ECE/TRANS/WP.29/2009/112  
27 July 2009

**Proposal for Corrigendum 1 to global technical regulation No. 9  
(Pedestrian safety)**

**Submitted by the Working Party on Passive Safety \*/**

Figure 12:..."

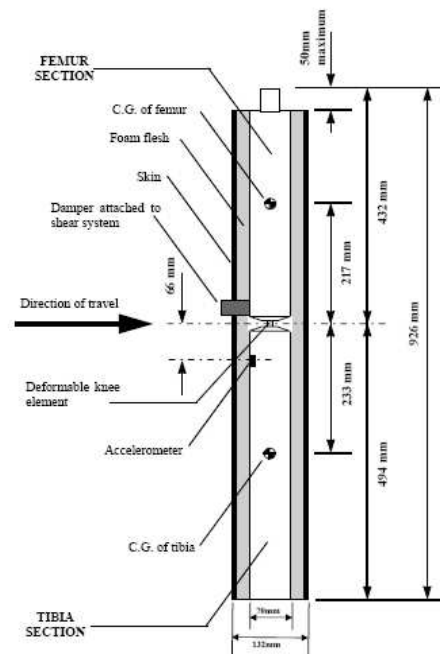
Paragraph 6.3.1.1.7.2., figure 12, replace by the following:

"6.3.1.1. ... test mass of  $13.4 \pm 0.2$  kg (see Figure 12). Dimensions of the various parts are detailed in Figure 12."
